**DECLARATION OF TIFFANY
FLOYD IN SUPPORT OF JOINT
MOTION TO SUPPLEMENT
RECORD WITH DEQ RESPONSE
TO EPA LETTER**

Response to the August 10, 2023 EPA Region 10 Letter to Idaho DEQ

**Perpetua Resources Idaho, Inc.
Stibnite, Idaho**

Permit to Construct No. P-2019.0047

Graph illustrates skewed dataset; use geomean or median for the average silt.

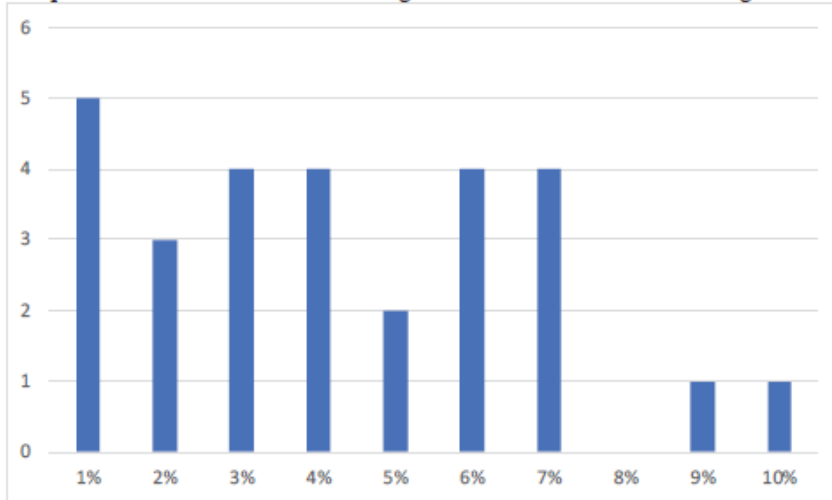
In response, IDEQ stated the use of site-specific median values for silt content is commonly accepted by IDEQ, and the values used in calculations were supported by PRI.³⁶ This response does not adequately justify why a median value rather than the arithmetic average is more appropriate taking into consideration the site-specific sampling. Given that a small difference in the silt content will result in an exceedance of the NAAQS, IDEQ's insistence on using a median silt content appears arbitrary and unreasonable and indicates that PRI has not demonstrated that the emissions will not cause or contribute to a NAAQS violation. On the contrary, operation of the SGP will likely cause or contribute to a violation of the PM₁₀ NAAQS.

Applying a median silt content value of 4.0% is neither arbitrary or unreasonable. After a thorough review of the background materials and statistical analysis, along with the administrative record, IDEQ contends that a 4.0% silt content value is reasonable and conservative.
